**ENVIRONMENTAL IMPACT ASSESSMENT, WASTE MANAGEMENT LICENSE AND WATER
USE LICENSE APPLICATION FOR THE 30 YEAR ASH DISPOSAL FACILITIES AT KENDAL
POWERSTATION**

16 April 2015 at 13H30, DWS Sedibeng Building

DWS Meeting Regarding Engineering Design

Project No : 12935

Typical Class C Landfill Barrier System

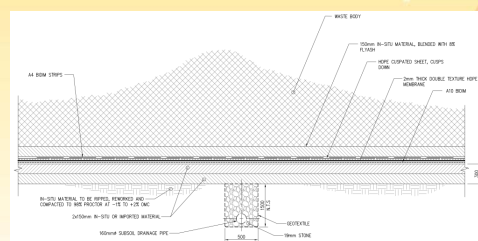
- 5.1 NR explained the proposed liner design. KM explained that DWS is looking for a composite effect, so that in case there is a hole in the geomembrane, there is clay to assist with the leakage. However, the A10 beneath the geomembrane will have an effect on transmissivity and cause the leak to spread out. KM explained that the DWS therefore recommends that the A10 be removed. NR explained that the CQA must then be spot on. KL explained that a full drum roll will be required on the final layer below the 2mm geomembrane. KL enquired whether a double textured HDPE geomembrane will be used. KL stated that the most important will be for the CQA to be implemented properly.

- 5.2 KL advised that construction is always difficult, and that Zitholele specified a non-woven needle punch of 200g/m² A4 over the cusped system. KL asked NR how he intends to join the geotextile without letting it blow in the wind. He asked if it will be continuous over the whole area and stitched or whether it will be heat seamed.

- 5.4 KM enquired about the A4 biddum on top of the cusped sheets, on the drawing it says that it is strips. NR explained that it is not fully over the cusped drains but only over the gaps.

NR enquired whether KL was referring to the biddim which KL confirmed. NR stated that the proposal is not to leave the biddum there for a long time. The fly ash must be blended into the *in situ* material and used to cover up the biddum to protect it. KL stated that the design is fine. He warned that the construction method will have to address what the contractor must do to avoid the biddum blowing around before the pioneer layer with the fly ash blend is placed. KL stated that there are various options to address this: boulders, stitching, heat seaming etc. KL stated that this detail must be addressed in the CQA plan.
